# SERVICE LETTER

No. 755C

Piper Aircraft Corporation

SUBJECT: Landing Gear Lock Actuator Rod  
and Rod End Bearing Inspection/  
Replacement.

SKETCH A

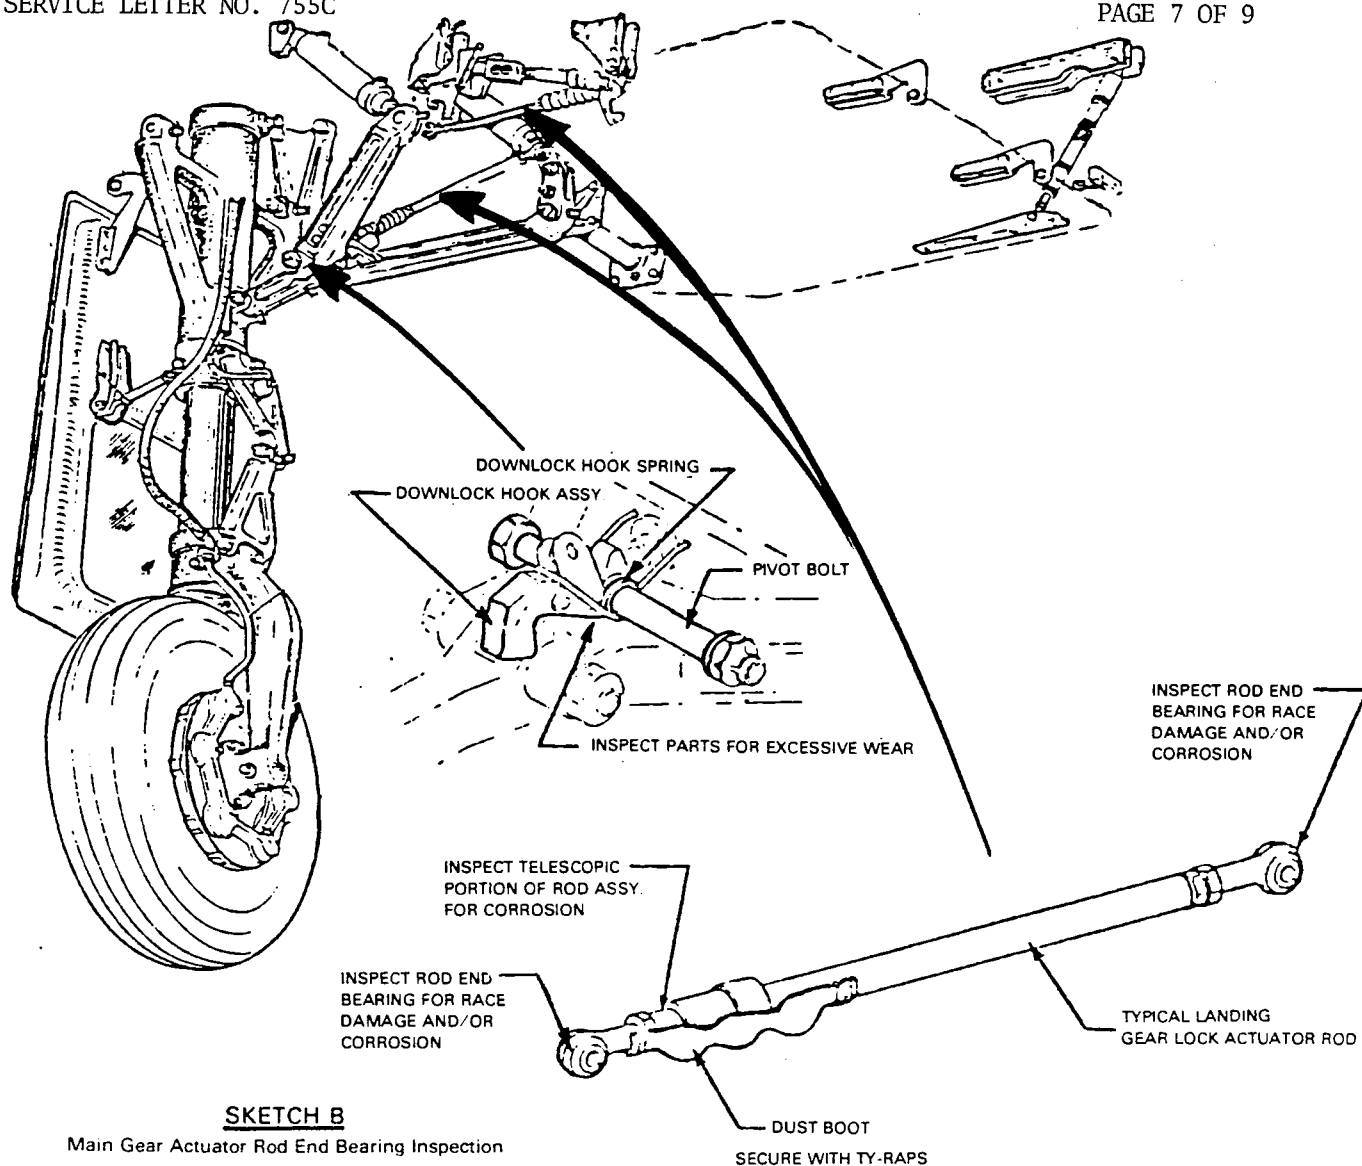
1. Locate and remove the nose gear lock actuator rod assembly from aircraft as shown.
2. Loosen the clamp attaching the dust boot to the landing gear lock actuator rod. Slide the dust boot back to expose the telescopic portion of the actuator rod assembly.

3. Inspect the telescopic portion of the landing gear lock actuator rod for evidence of corrosion.
  - a. If corrosion is evident, the landing gear lock actuator rod assembly should be replaced.

- b. If no corrosion exists, lubricate the telescopic portion with MIL-G-81322, 81827 or MIL-G-21164C lubricant.
4. Reposition and secure dust boot on each landing gear lock actuating rod assembly.

5. Inspect each rod end bearing for evidence of race damage and/or corrosion.
  - a. If corrosion is evident and/or ball and race of bearing shows evidence of damage (ball must rotate freely in race), it will be necessary to replace that bearing.

- b. If existing bearings show no evidence of corrosion or damage, lubricate bearings with MIL-L-7870 lubricant.
6. If a new main gear lock actuator rod assembly (assemblies) is being installed, lubricate the telescopic portion as described in 3b above, and the rod end bearings with MIL-L-7870 lubricant. Install existing dust boot on actuator rod assembly as shown.

7. Reinstall the nose gear actuator rod assembly on aircraft. Check system function and rigging; adjust as necessary using the appropriate Navajo Service Manual. Refer to Sketch "C" for the correct method of adjusting rod end bearings.

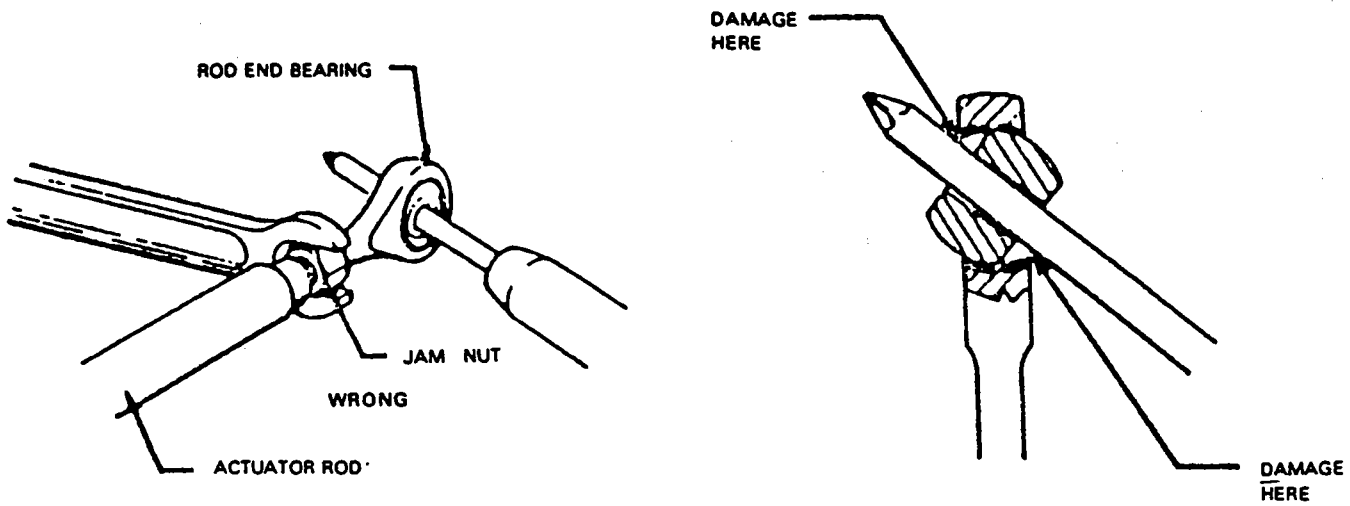
1. Locate and remove the main gear lock actuator rod assemblies from aircraft as shown. Accomplish on left and right main gear assemblies.
2. Loosen the clamp attaching the dust boot to the landing gear lock actuator rod assembly. Slide the dust boot back to expose the telescopic portion of the actuator rod assembly.

3. Inspect the telescopic portion of each landing gear lock actuator rod assembly for evidence of corrosion.
  - a. If corrosion is evident, the landing gear lock actuator rod assembly should be replaced.

- b. If no corrosion exists, lubricate the telescopic portion with MIL-G-81322, 81827 or MIL-G-21164C lubricant.
4. Reposition and secure the dust boot on each landing gear lock actuating rod assembly.

5. Inspect each rod end bearing for evidence of race damage and/or corrosion.
  - a. If corrosion is evident and/or ball and race of bearing shows evidence of damage (ball must rotate freely in race), it will be necessary to replace that bearing.

- b. If existing bearings show no evidence of corrosion or damage, lubricate bearings with MIL-L-7870 lubricant.
6. If a new main gear lock actuator rod assembly (assemblies) is being installed, lubricate the telescopic portion as described in 3b above, and the rod end bearings with MIL-L-7870 lubricant. Install existing dust boot on actuator rod assembly as shown.

7. Remove the main gear downlock hook assembly. Thoroughly clean the downlock hook assembly, downlock hook spring and pivot bolt and inspect each part for evidence of excessive wear. If any part or parts show excessive wear, those parts should be replaced.

8. Reinstall the downlock hook assembly, spring and pivot bolt on aircraft. Lubricate pivot bolt and hook with MIL-G-81322, 81827 or MIL-G-21164C Lubricant.

9. Reinstall the main gear lock actuator rod assemblies on aircraft. Check system function and rigging; adjust as necessary using the appropriate Navajo Service Manual. Refer to Sketch "C" for the correct method of adjusting rod end bearings.

IMPROPER METHOD OF ADJUSTING ROD END BEARINGS  
(RESULTING IN LOCKED BALL)

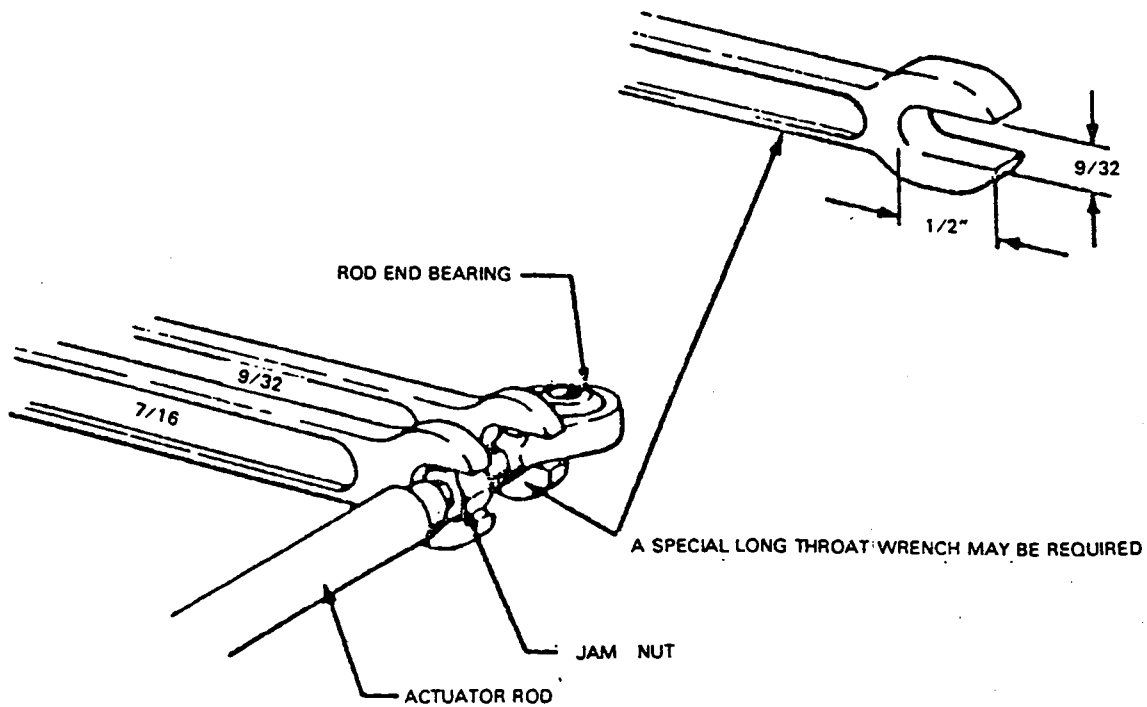
NOTE: It has been found that rod end bearings race damage - incurred during maintenance/rigging activity - has resulted in landing gear system difficulties and/or premature rod end bearing replacements. This Service Release also provides a recommended method for backholding the bearing assembly while adjusting the adjacent jam nut to prevent bearing race damage (refer to attached instruction data for details).

CORRECT METHOD OF ADJUSTING ROD END BEARINGS

SKETCH D

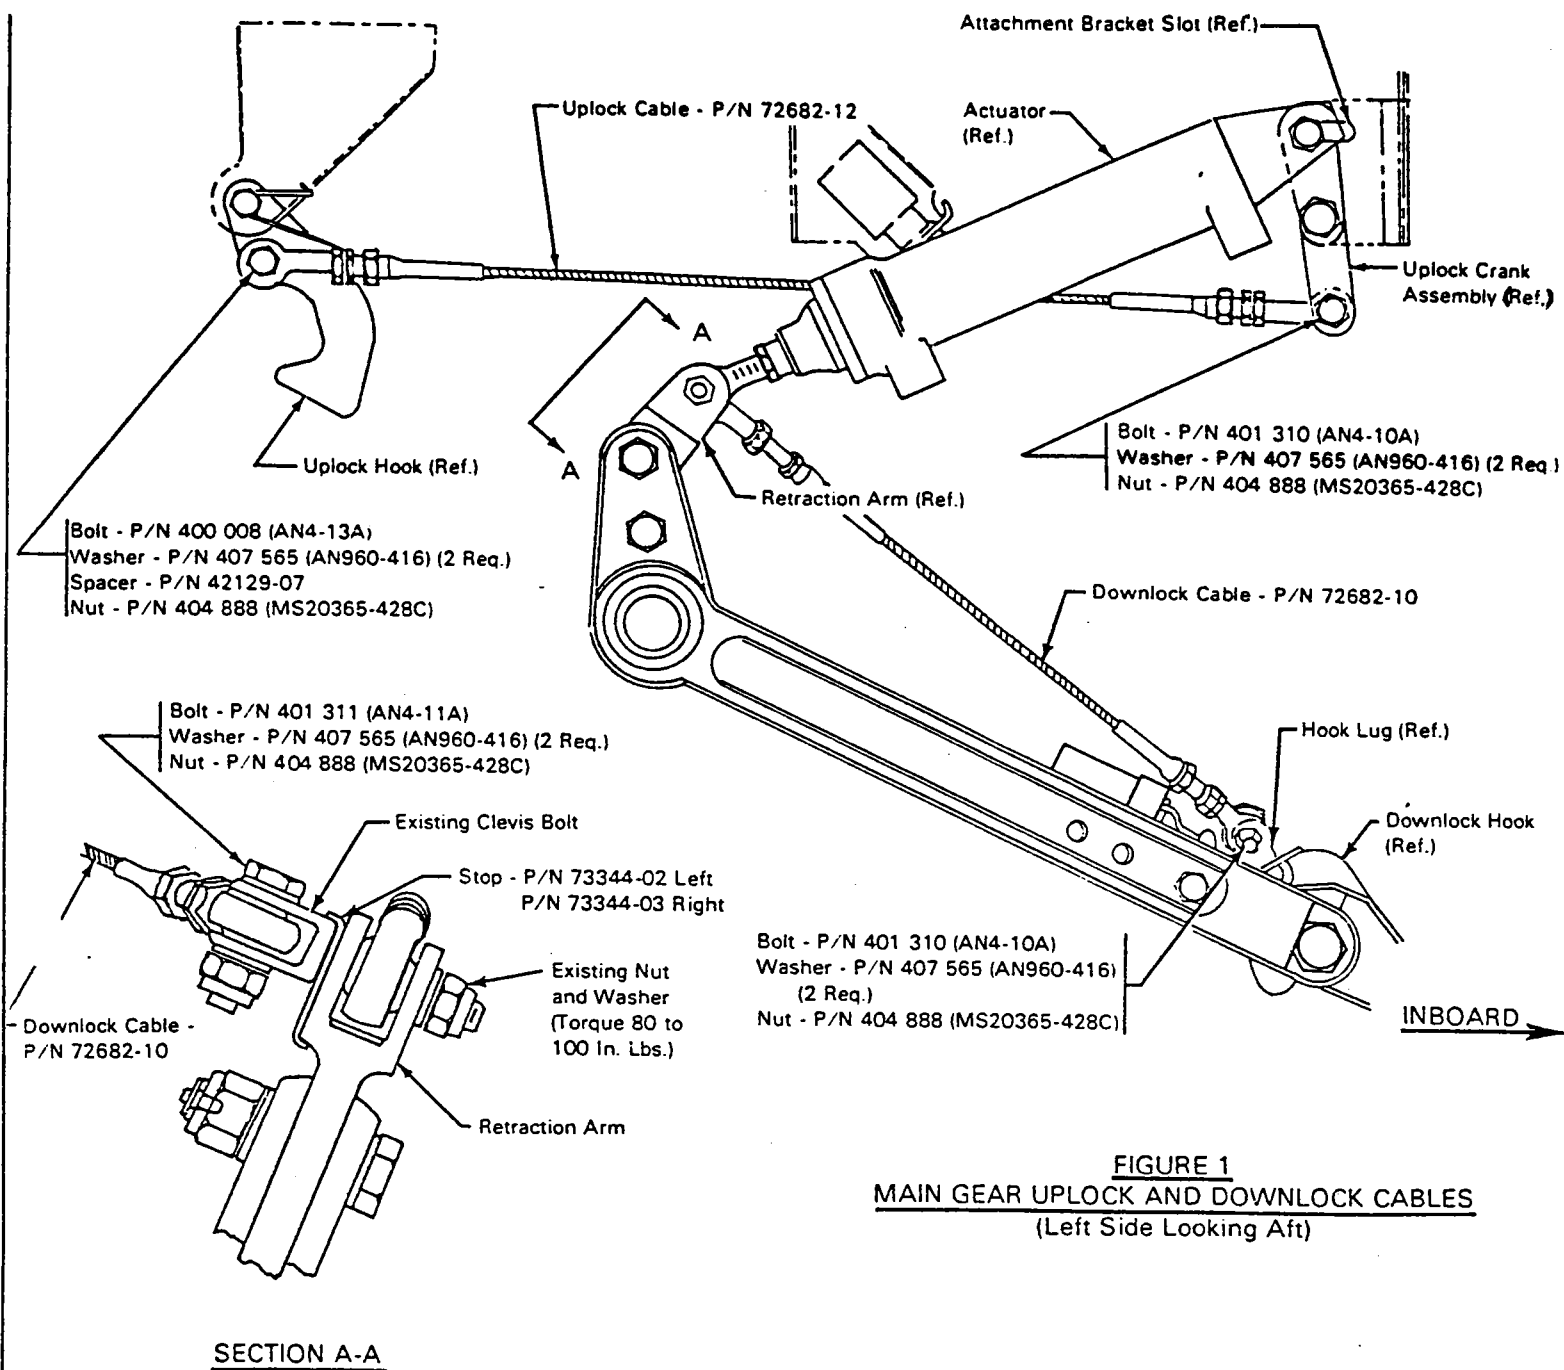
PURPOSE: Above affected models and serial numbers of aircraft were delivered with the new landing gear uplock and downlock cable assemblies. Installation of these stops between the retraction arm and clevis bolt will prevent possible rotation of the downlock cables and insure safe gear indications.

NOTE: Refer to Sketch D, Section A-A of this Service Letter for anti-rotation stop installation.

1. Remove nut and washer from the clevis bolt (fork) connecting the down-lock cable to the retraction arm.
2. Pull out the clevis bolt and install Stop, Piper Part Number 73344-02 (left side) and 73344-03 (right side) over the bolt and reinsert bolt through the retraction arm.
3. Install washer and nut and torque 80 to 100 inch pounds.
4. Repeat procedure on the opposite gear.
5. Make proper logbook entry of compliance with PART III of this Service Letter.
